# FORMAL OBJECTION TO PLANNING AMENDMENT

## [2025/70/91279/E]

I am writing to object to planning application [2025/70/91279/E] for the proposed installation of multiple industrial air-source heat pumps (ASHPs) and a power substation, and associated mechanical infrastructure, including an external electrical plant area on the Kenmore Drive development site. This proposal raises serious concerns about its timing, siting, and potential impacts on neighbouring residential properties, especially mine.

Images 6: Photographs illustrating the ASHP compound's immediate proximity to my boundary and north-facing bedroom window

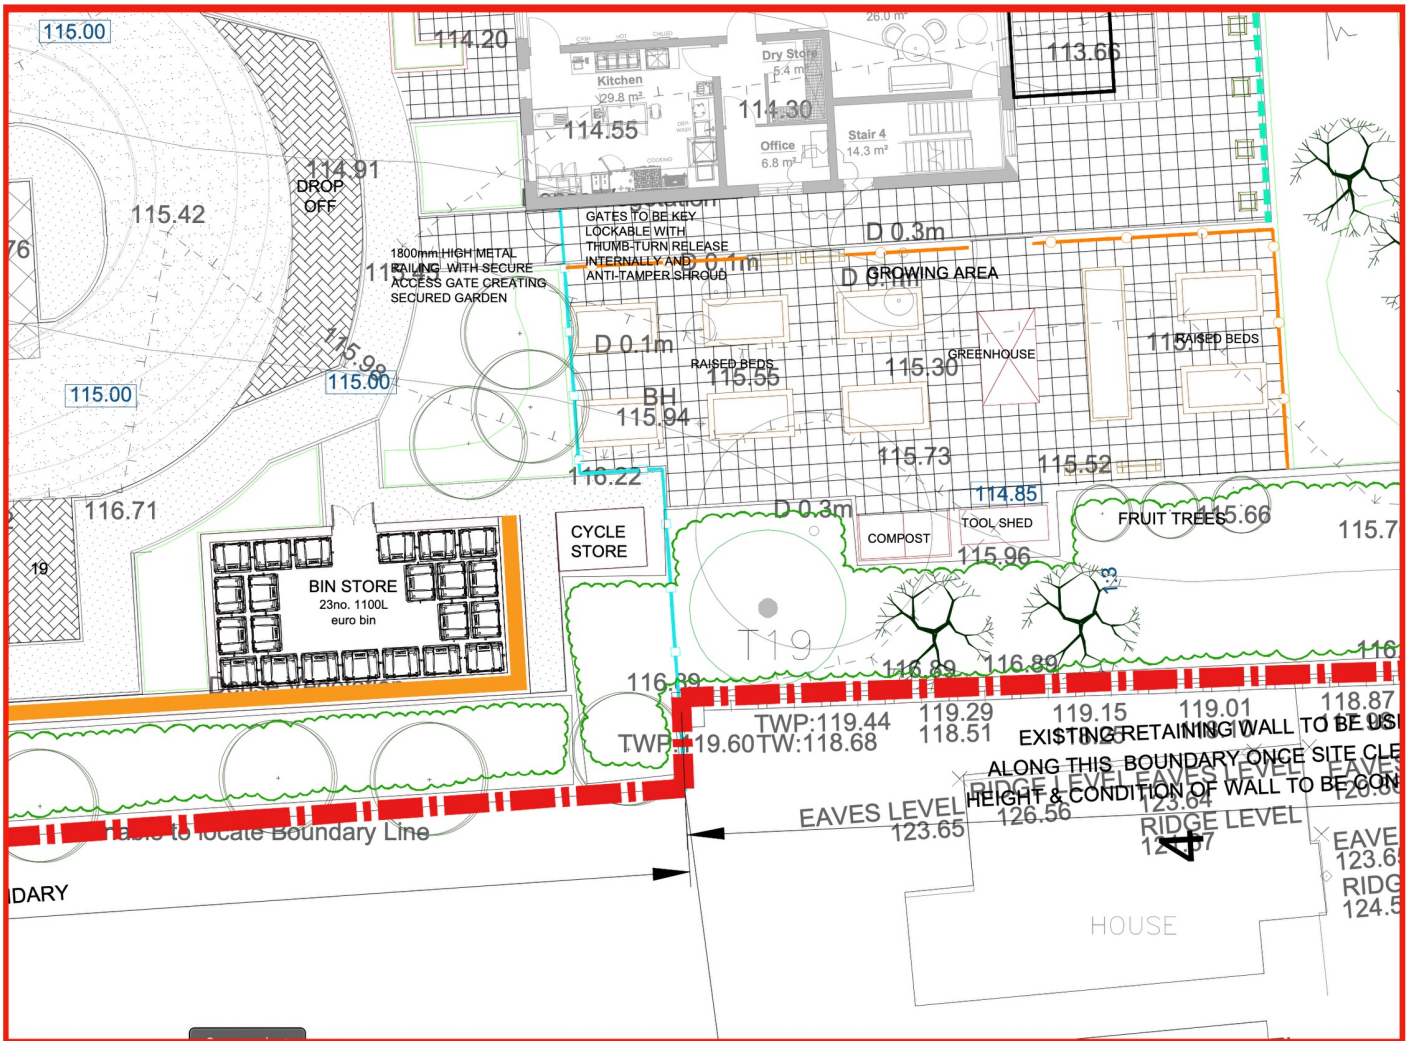
(See Images 6–7: ASHP compound proximity to my boundary and north-facing bedroom window.)

Reverberant “slot” geometry between building and boundary: The ASHP compound is proposed within a narrow slot between the new building’s south wing and my boundary, measured at approximately 2.5 m from the pillar fence line to my façade on plan 1101390. Two largely reflective surfaces facing each other (masonry façade and boundary/retaining wall) will produce strong early reflections and a “canyon” effect, increasing the effective sound at my windows and garden. The Nova Rev 003 model does not account for these local reflection gains or for diffraction around the enclosure/wing corner and should be revisited.

- Geometry-driven amplification: The ASHP enclosure and building face form a hard-walled “canyon” facing my property, with a very small stand-off to the boundary ( $\approx 2.5$  m, plan 1101390). This promotes façade reflections and low-frequency build-up, increasing both airborne noise and the likelihood of structure-borne transmission into my pile-founded slab. No ISO 9613-2/CNOSSOS 3-D propagation with reflective façades, nor any BS 6472-1 vibration assessment, has been provided to account for this foreseeable amplification;
- Continuous noise and potential vibration from ASHPs and the substation;
- Ventilation noise/odour from the kitchen;
- Fire/safety concerns from the external plant area (likely inverter/battery elements) and large refuse storage;
- Hygiene risks from commercial-scale bin capacity.
